**From:** Kenneth Gibbs  
**To:** DCOZ - ZC Submissions (DCOZ)  
**Subject:** Letter in opposition to ZC No. 24-15  
**Date:** Friday, June 20, 2025 8:57:12 AM  
**Attachments:** image.png

I am an immediately adjacent neighbor of the proposed ZC No. 24-15, writing to express opposition to the 901 Monroe St development as currently proposed. While I support development of the site, the current proposal creates numerous adverse effects for immediate neighbors and should be redesigned before moving forward. Below are a number of discretionary design aspects that will adversely impact the quality of life for longstanding community members. I request that ZC require the developers redesign the project for more appropriate scale and to better protect the safety and health of immediate neighbors.

A drawing of a townhouse   Description automatically generated

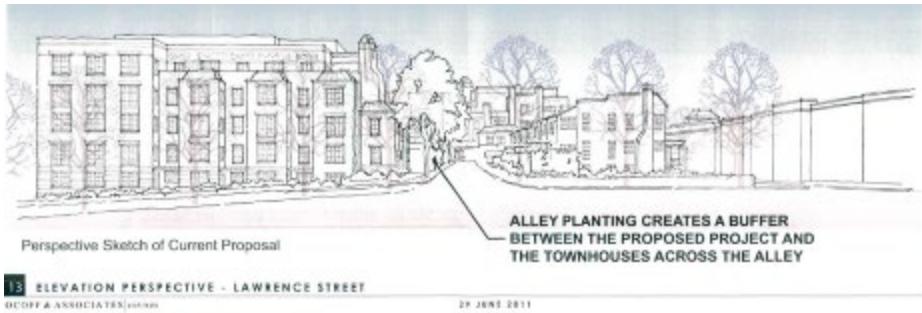
**Excessive scale.** The proposed 6-story, 75-foot building will dominate the surrounding 2-story homes, blocking air and sun of neighboring properties, and obstructing sunlight for children's bedrooms, gardens, and solar panels. No other building on this side of the train tracks approaches this scale (including the two 4-story DC buildings across the street, adjacent to the train tracks). Moreover, No. 24-15's design does not integrate well with the surrounding neighborhood.

- The design should incorporate 45-degree setbacks along the alley to avoid adverse

effects for the adjacent neighbors, and improved compatibility with the neighborhood.

→ To integrate with the surrounding homes and buildings, a maximum of 4-5 stories would be more appropriate. This could be accomplished by including underground parking instead of above-ground parking.

→ The image below, of the 901 Monroe St 2011 design, shows appropriate setbacks facing the immediate neighbors, as well as a tree buffer in the alley.
